U.S. SOIL

# Technical Revision: Maverick Placer 2025

Permit: Maverick Placer - M-1979-206

# Appendix - Boundary Maps

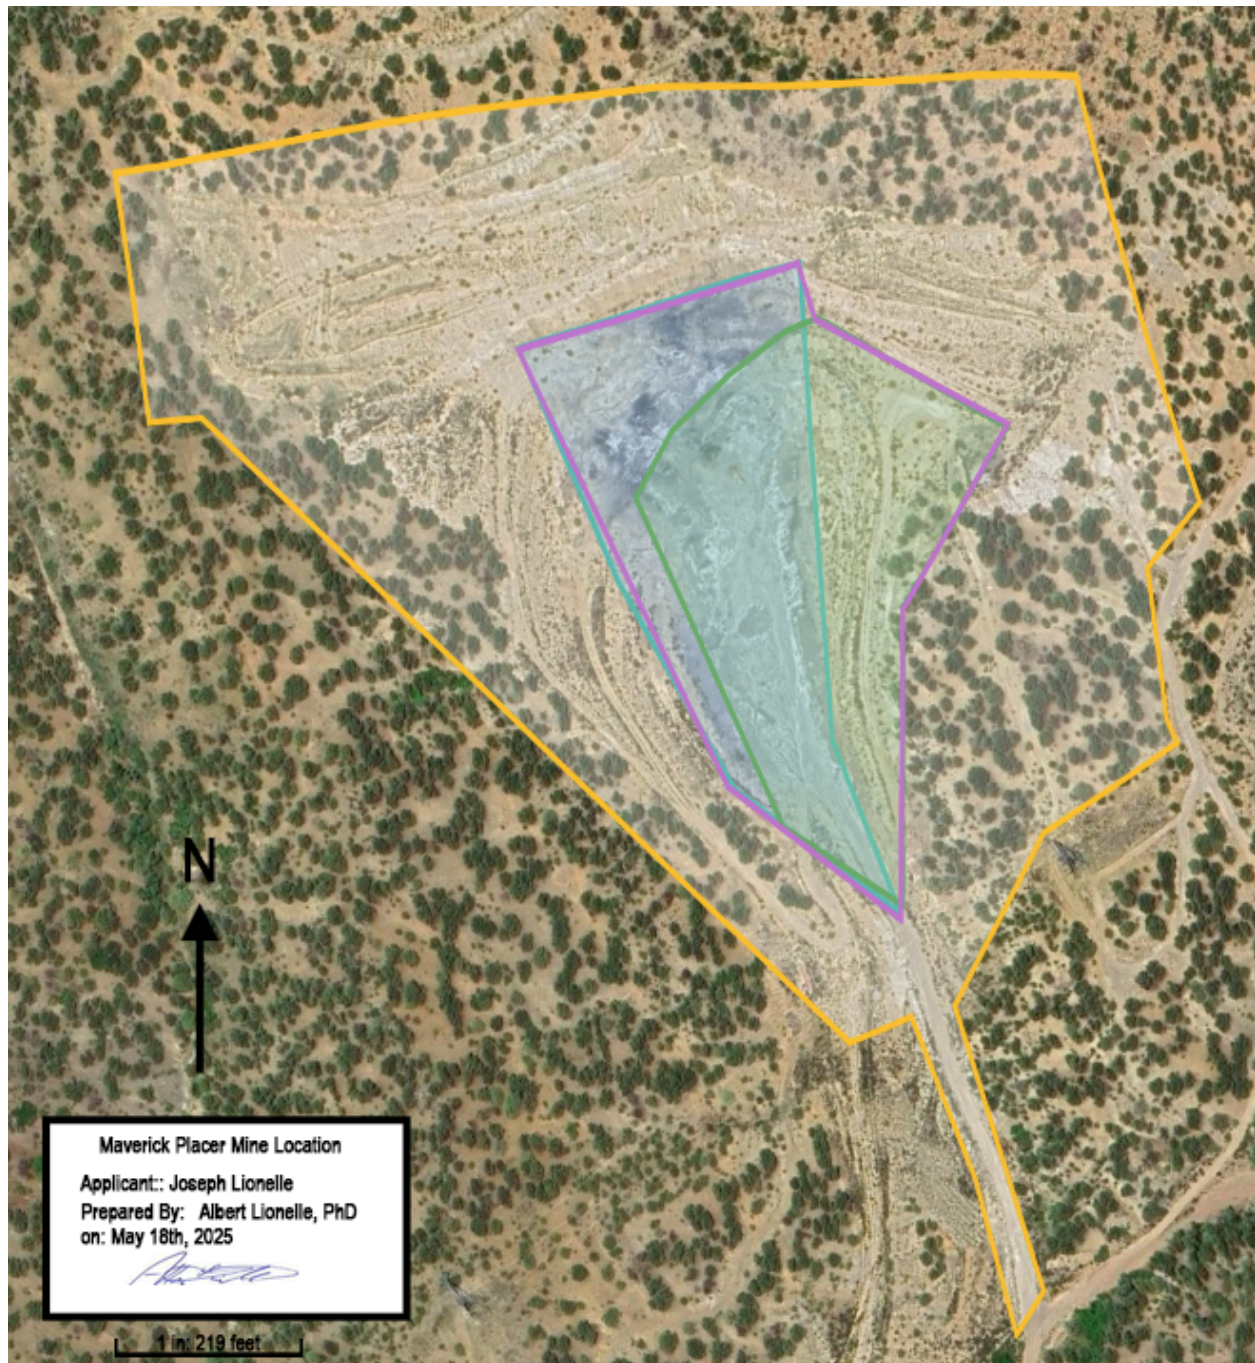
## Total Area:

Primary Mine Area: 28.43 acres

Ore Store Area: 8.57 acres

Total: 37.00 acres
